Informal document N° 19
(29th GRSP, 7-11 May 2001
agenda item 2.8)

AIRBAG WARNING - ECE REGULATION 94

OICA contribution

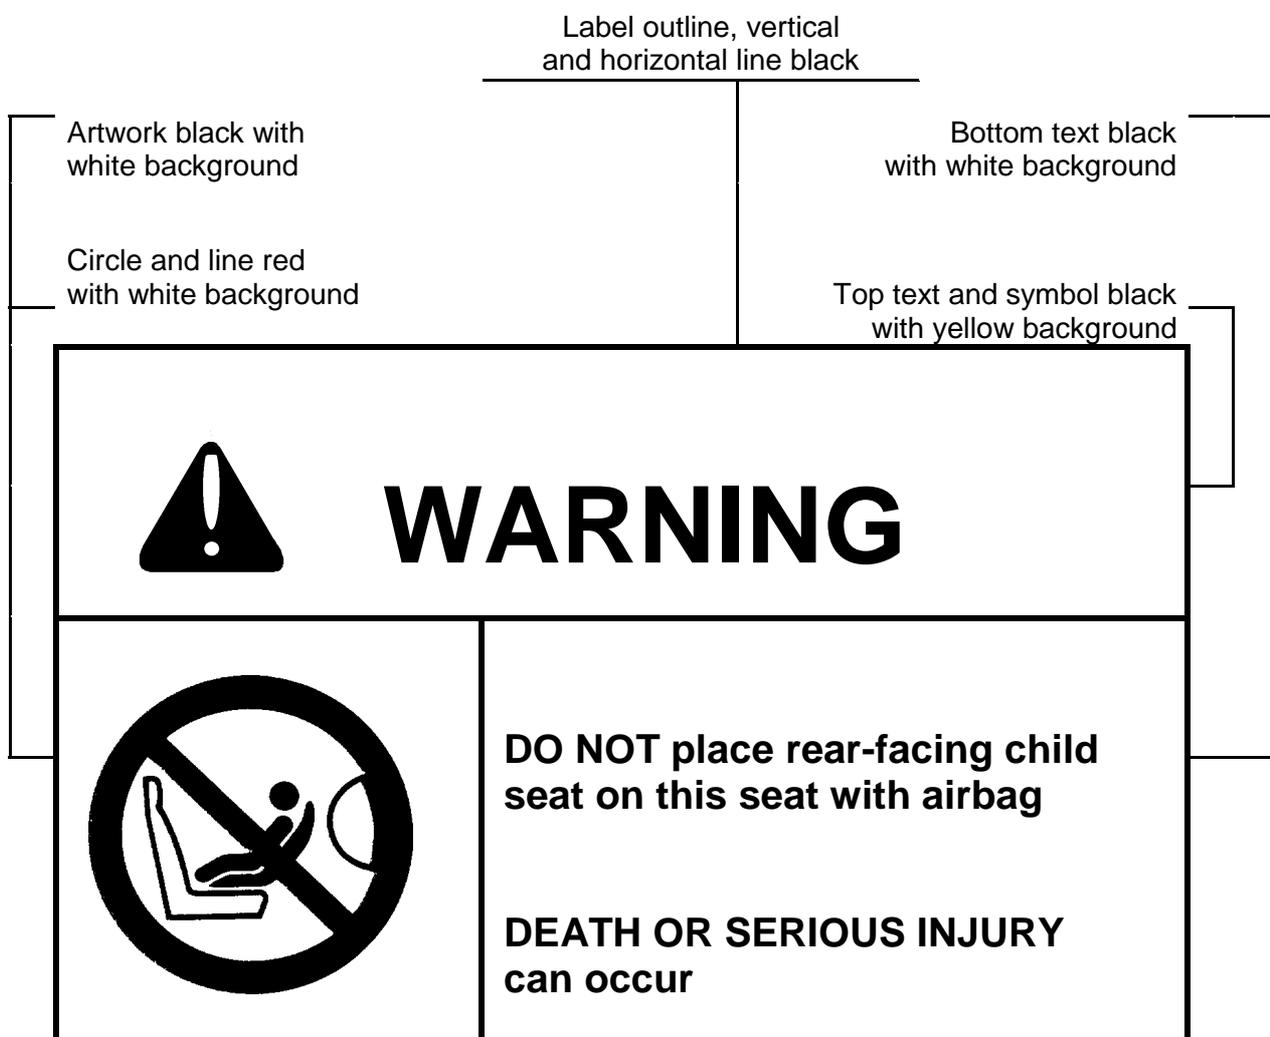
Paragraphs 6.1.2 to 6.2.3, replace by:

- "6.1.2 For a vehicle fitted with a passenger airbag intended to protect occupants other than the driver, this information shall consist of the warning label described in paragraph 6.2 below.
- 6.2 A vehicle fitted with one or more airbags which cannot be deactivated manually shall carry information about the extreme hazard associated with the use of rearward-facing child restraints on seats equipped with airbag assemblies.
- 6.2.1 As a minimum, this information shall consist of a label containing a pictogram and text warning as indicated below.

The label shown above may be adapted such that the size, layout, colours and/or pictogram differ from the example above; however, the text content shall meet the above prescriptions.
